BROWN & ROOT, INC. CPSES JOB 35-1195	PROCEDURE NUMBER	ARMS INDEXED REVISION DATE	EFFECTIVE DATE	PAGE
	CCP-22	3	3/4/82	1 of 11
TITLE: STRUCTURAL STEEL ERECTION	ORIGINATOR:	<i>CE Hooton</i>		3-2-82 DATE
	REVIEWED BY:	<i>N/A [Signature] 3/2/82</i>		DATE
		<i>[Signature] TUGCO QA</i>		3-3-82 DATE
	APPROVED BY	<i>DC [Signature]</i> CONSTRUCTION PROJECT MANAGER		3-4-82 DATE

COMANCHE PEAK STEAM ELECTRIC STATION

Construction Procedure
DOCUMENT CHANGE NOTICE NUMBER 6

Notice applicable to Construction Procedure No. 35-1195- CCP-22 Rev. 3

VENDOR CERTIFIED
DRAWING REV. NO. 3
BY *[Signature]* DATE 7/1/88

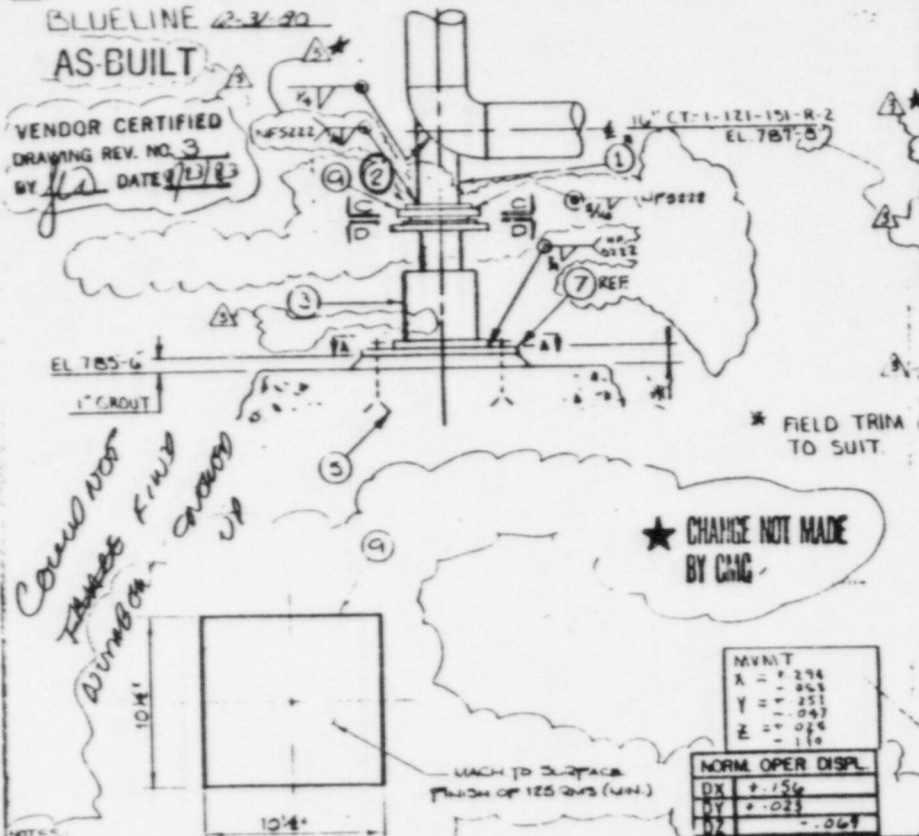
*Could not
find
dimension
shown*

* CHANGE NOT MADE
BY CMC

VENDOR CERTIFIED
DRAWING REV. NO. 3
BY DATE 10/6/93

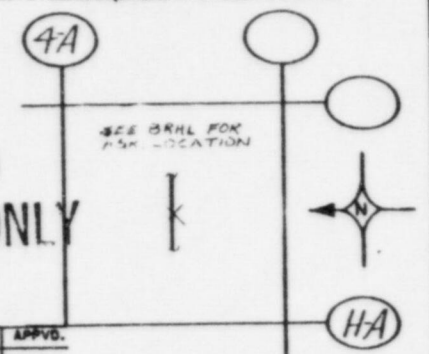
REV	DESCRIPTION	DATE	OWN	CHKD	APPVD
1	QTYD AS NOTED REF. CMC 5276281, 64190R1	1/1/91	SW	RD	STP
2	DATE NOT SHOWN IN 'AS-BUILT'				
3	REVISIONS TO BE TREATED WITH A RUST PREVENTATIVE	1/1/91	SW	RD	STP

FOR NOTES SEE DWG. MSB-0688-010 SHEET 2
 1 FOR INDIVIDUAL PART SIZES SEE PURCHASE ORDER NO. CPD-0324
 JOB NO. 3416; '0' DWGS AS REFERENCED IN THE BILL OF MATERIAL
 ABOVE.

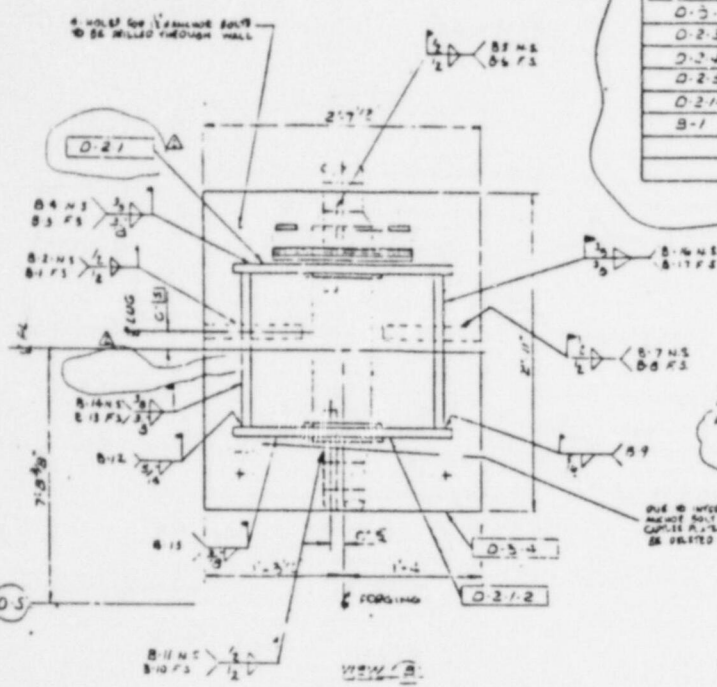
DUE TO INTERFERENCE BETWEEN THE
 MOMENT BOLT AND THE FRONT OF THE
 CAPSULE PLATE, THE FRONT END SHALL
 BE DRILLED BEHIND THE POINT OF INTERFERENCE.
